Caval Ridge Mine Change Request 5 Rail Alignment Changes

October 2011

Figure 3.2 Proposed rail alignment change

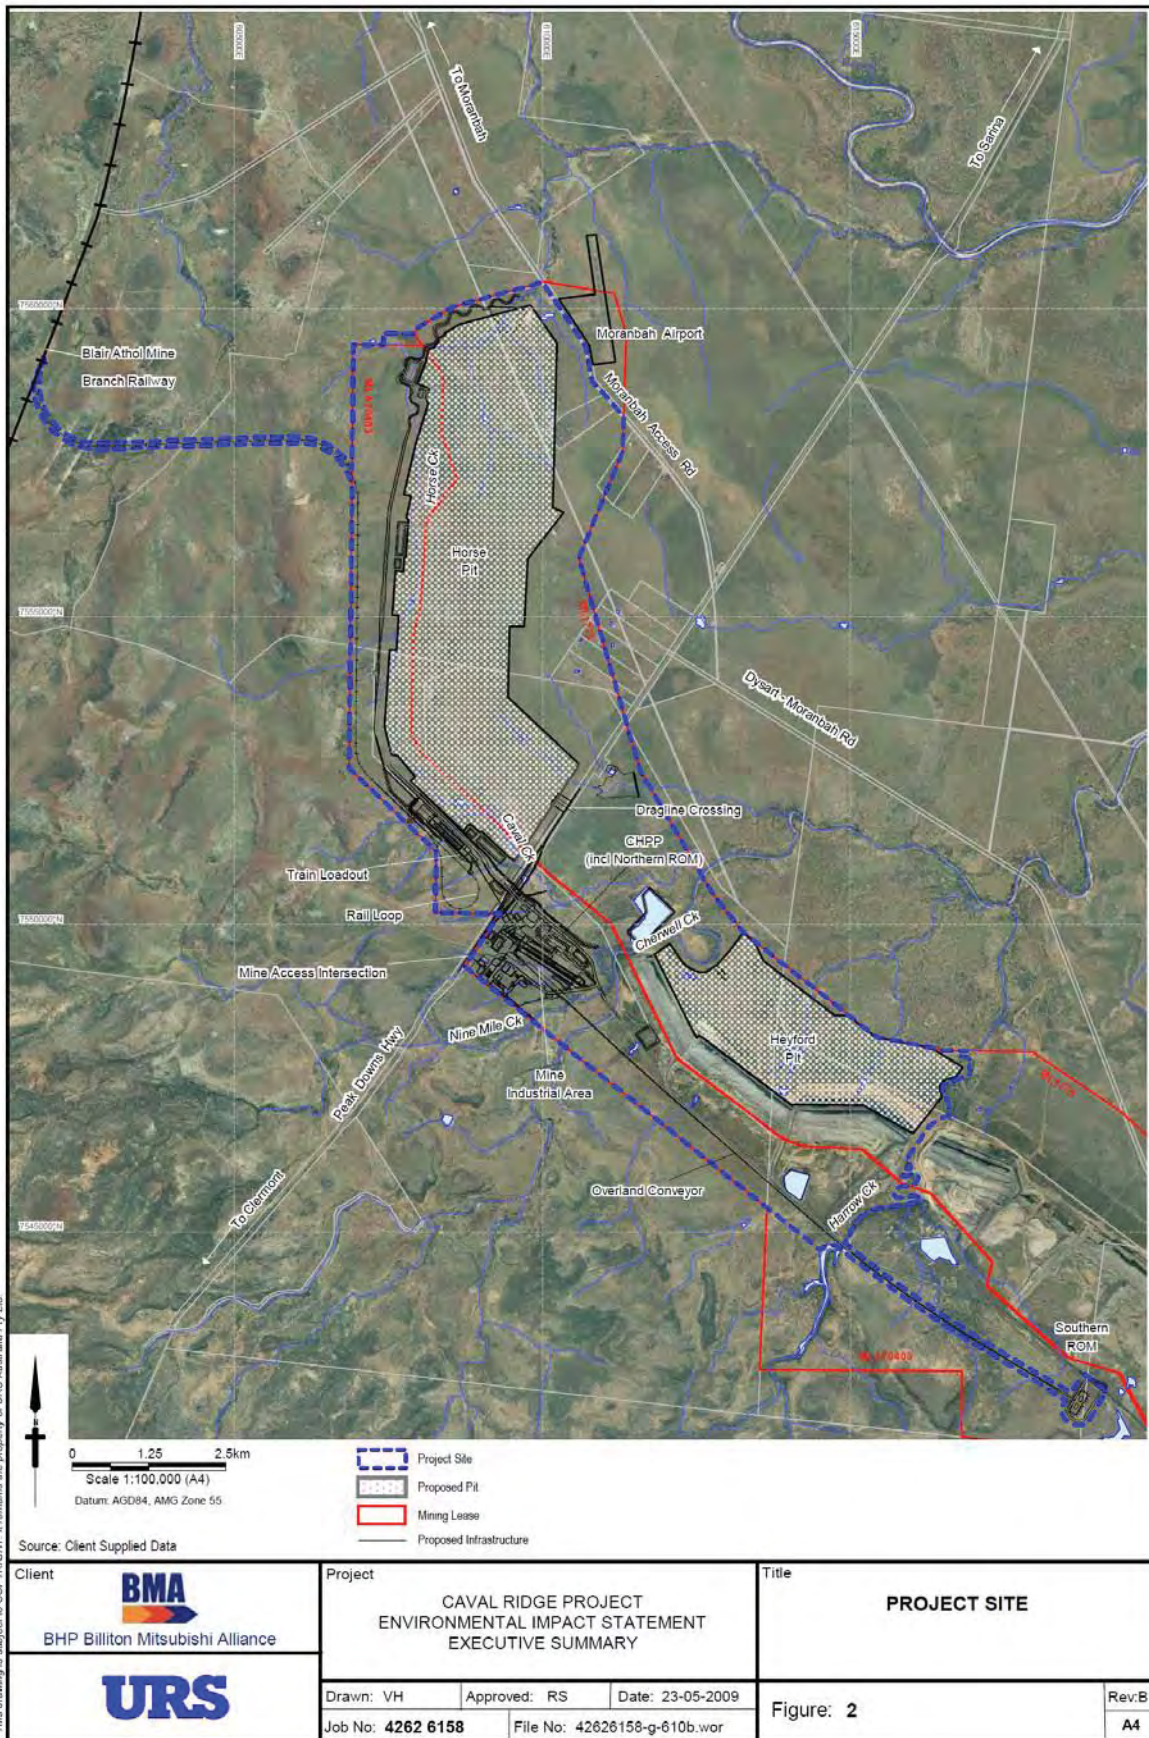
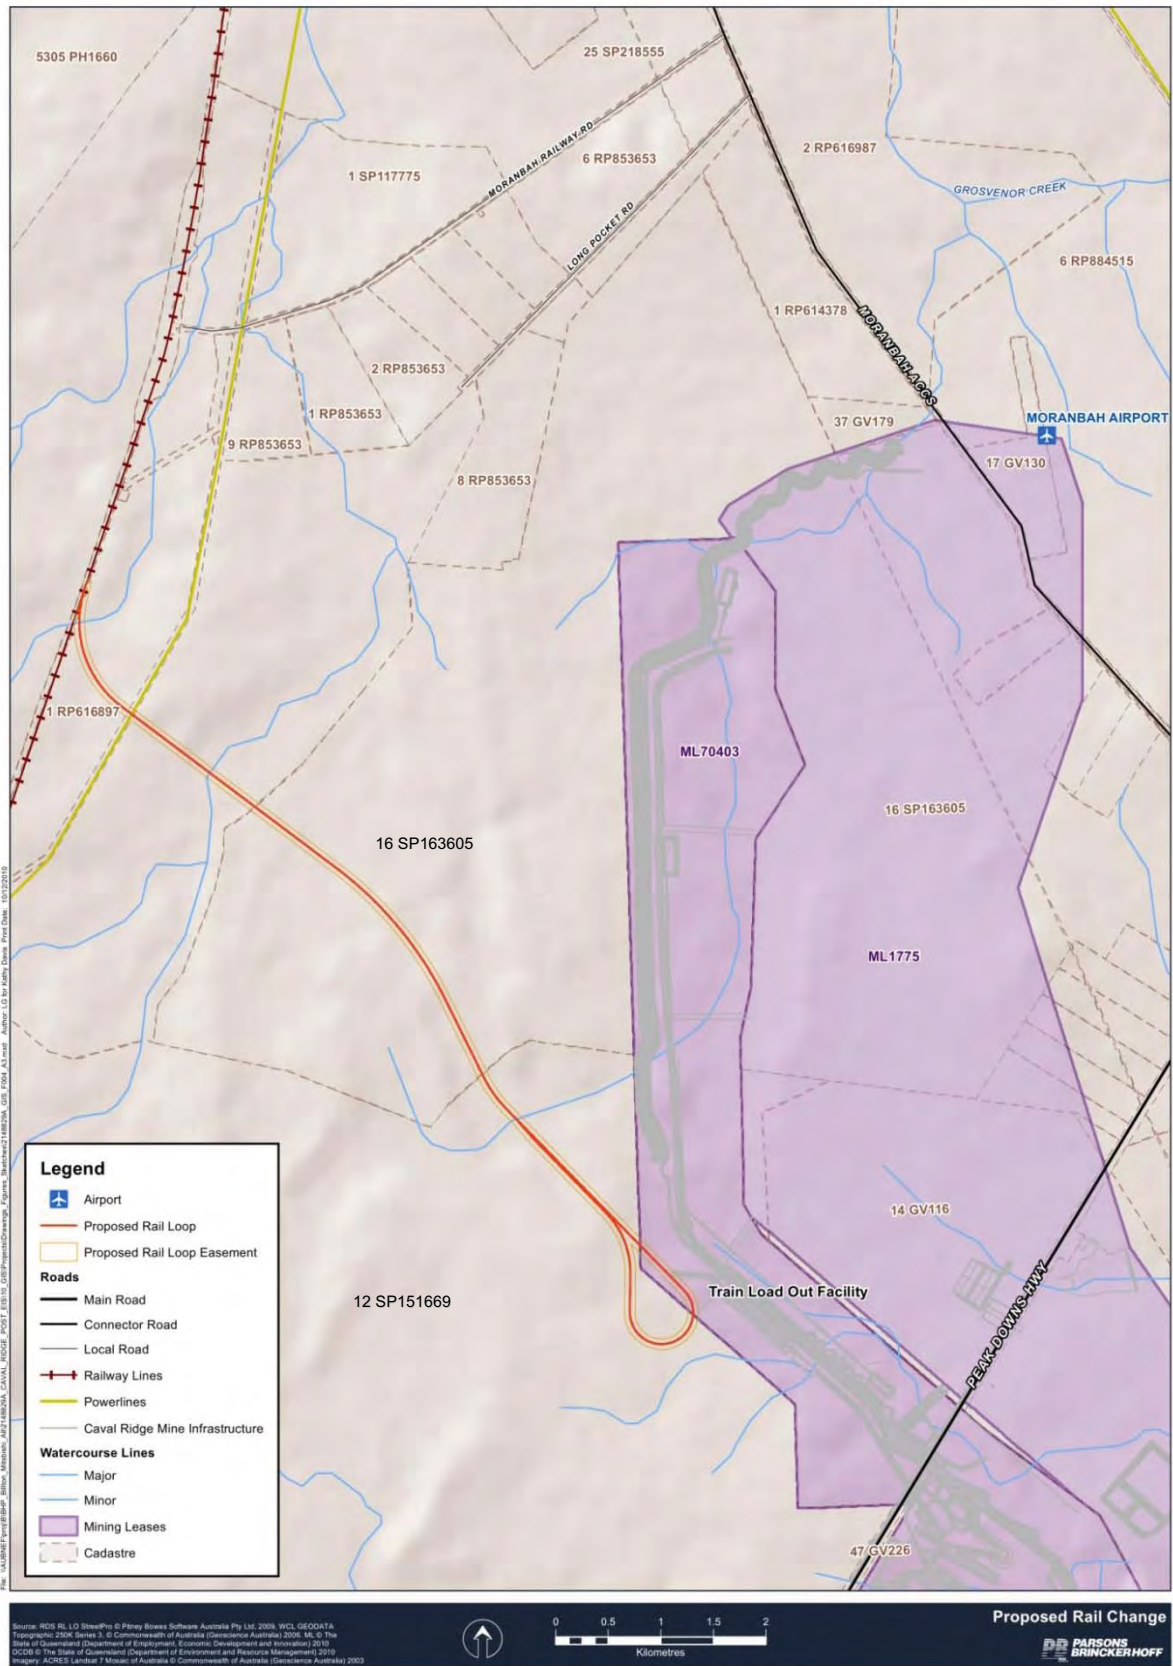
BMA has developed an alternative alignment for the rail line between the existing Blair Athol Line and TLO facility. The proposed rail alignment is shown in Figure 3.2 of this Change Request.

The rail spur will exit the Blair Athol Line at the same point as originally proposed in the EIS/SEIS. However, it is proposed to run in a south-easterly direction to the TLO facility on ML70403. The rail loop adjoins the TLO facility. The proposed rail alignment still traverses Lot 1 RP616897, Lot 16 SP163605 and Lot 12 SP151669. Lot 1 RP616897 and Lot 12 SP151669 are now owned by BMA, which was not the case at the time the EIS and SEIS were prepared (refer Figure 3.2).

The proposed changes to the rail line are limited to a route which exists outside ML70403. Train movements and frequencies will remain the same as described in the EIS and SEIS. Table 3-1 of this Change Request outlines the key parameters of the proposed rail line in comparison to the approved rail line.

Rail line parameter	EIS	Rail Proposed Change	Difference
Total length (km)	17.08 km	12.50 km	- 4.58 km
Corridor width (m)	100.00 m	100.00 m	No difference
Length, outside ML70403 (km)	6.35 km	11.65 km	+ 5.30 km
Length, inside ML70403 (km)	10.74 km	0.08 km	- 10.66 km
Area, outside ML70403 (ha)	62.38 ha	102.58 ha	+ 40.20 ha
Area, inside ML70403 (ha)	93.01 ha	8.49 ha	- 84.52 ha

Figure 1: EIS rail alignment (blue) and proposed change to rail alignment (green)

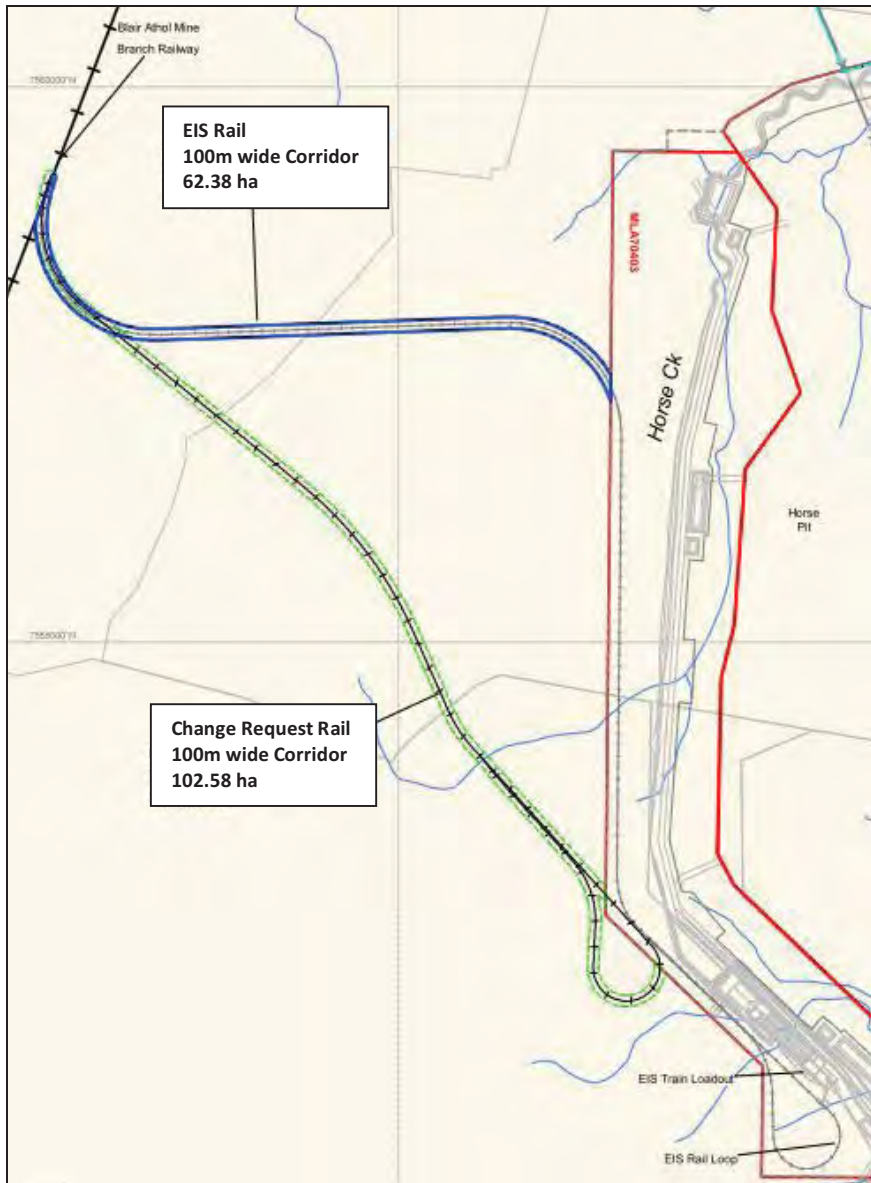
Since completion of the EIS and Supplementary EIS (SEIS) for the Caval Ridge Mine, BMA have developed an alternative alignment for the rail spur and loop (refer to Figure 1 below). The amended design diverts south-east from the Blair Athol Line to the rail loop and the TLO facility on ML70403. The TLO facility and part of the rail loop (850 m) is situated within the area of disturbance assessed as part of the EIS, and as such has not been assessed for inclusion in this Change Request.
